**PLANNED UNIT DEVELOPMENT  
& SUBDIVISION STAFF REPORT**

**DEVELOPMENT NAME** Paul Persons Subdivision, Resubdivision of Lot 1

**LOCATION** 4474 Halls Mill Road  
(North side of Halls Mill Road, 4/10 mile± West of the North terminus of Riviere du Chien Road)

**CONTEMPLATED USE** Planned Unit Development Approval to allow multiple buildings on a single building site with shared access between building sites, and Subdivision Approval to create two lots.

# SITE PLAN

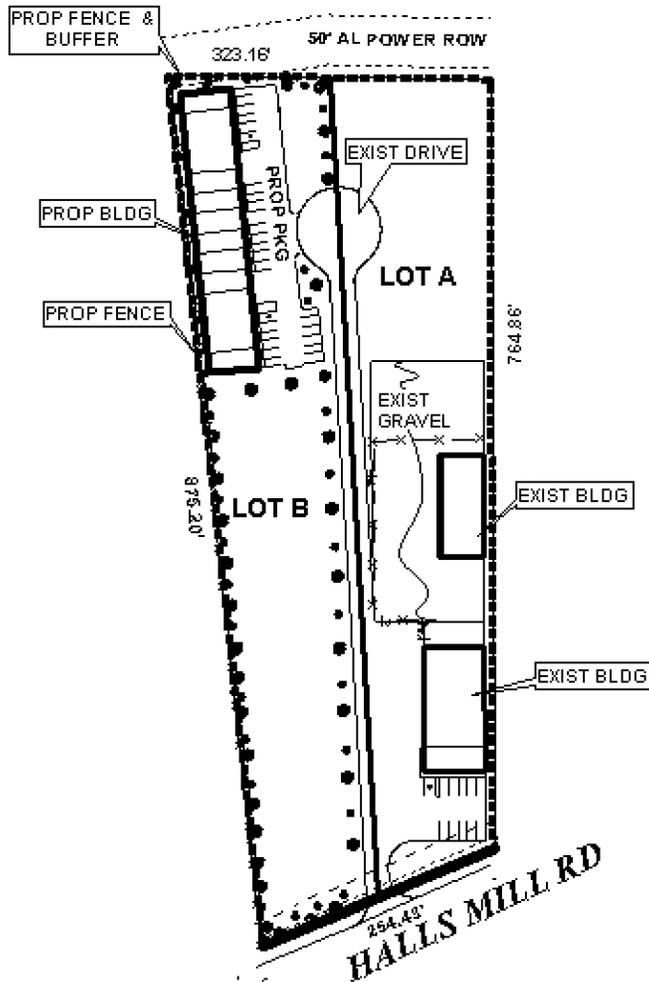
The applicant is requesting subdivision of the existing lot to create two lots, and a Planned Unit Development to allow multiple buildings on a single building site with shared access between building sites. New development is proposed for the rear of the proposed "lot B," and will include what appears to be office and warehouse space; over half of "lot B" will remain undeveloped at this time.

Both proposed lots will be served by an existing common driveway that results in one curb-cut onto Halls Mill Road. The driveway, has a cul-de-sac at the terminus that is approximately 80 feet in diameter. It is not clear if the existing driveway meets minimum construction standards of the City of Mobile.

Section V.D. of the Subdivision Regulations recommends a depth to width ratio of 3.5 or less. As proposed, the depth to width ratio for the lots will range from 6.22 to 6.66. The site, in its current lot configuration has a depth to width ratio of 3.22. While there are other sites nearby with depth to width ratios in excess of what is recommended within the Subdivision Regulations, the creation of additional lots nearly twice the recommended ratio does not seem appropriate. Furthermore, the depth of the property essentially results in the creation of a cul-de-sac in excess of the 600 feet recommended in the Subdivision Regulations, and thus creates a potential hazard in terms of access for fire and emergency vehicles to the rear of the property.

The site plan shows proposed new development occurring at the rear of lot B. This design implies that the front portion of lot B will be developed at a future date, either through expansion of the existing development, or a new business. The proposed development of the site, as depicted, may create a future situation where resubdivision would be desired by business owners. Resubdivision of the proposed lots may not be possible in the future because the site may lack adequate street frontage for future lots, and the existing configuration with a private driveway may not allow the site to be resubdivided and designed to meet Subdivision Regulation and Zoning Ordinance criteria.

It should also be noted that when the zoning for the site was changed in 1997 from B-1, Buffer Business District, to B-3, Community Business District, one of conditions for the rezoning was *“provision of a 20 foot buffer strip, to be left in a natural vegetative state with in-fill plantings as determined necessary by the Land Use Staff, along the North and West property lines.”* The site plan for the application in question depicts a 10 foot buffer on the North and West sides, adjacent to the proposed new construction, which would not comply with the conditions of the approved rezoning. The purpose of the buffer was to protect existing residential development that is adjacent to the site. Therefore, the site plan should be revised to reflect the conditions approved as part of the 1997 rezoning of the site.

**Planned Unit Development:** Based upon the preceding, this application is recommended for Holdover until the August 17<sup>th</sup> meeting, with revised materials due to Urban Development by July 24<sup>th</sup>, to allow the following items to be addressed: 1) revision of the site plan to fully

comply with the conditions associated with the 1997 rezoning of the site; 2) provision of evidence that all of the existing development on the site was undertaken with the proper permits; 3) if a portion of the existing development on the site was not properly permitted, provision of a written plan outlining how existing unpermitted development will be brought into compliance with all applicable municipal codes and ordinances; and 4) revision of the site plan and subdivision layout to address depth to width ratio concerns and future subdivision concerns.

**Subdivision:** Based upon the preceding, this application is recommended for Holdover until the August 17<sup>th</sup> meeting, with revised materials due to Urban Development by July 24<sup>th</sup>, to allow the following item to be addressed: 1) revision of the subdivision layout to address depth to width ratio concerns and future subdivision concerns.
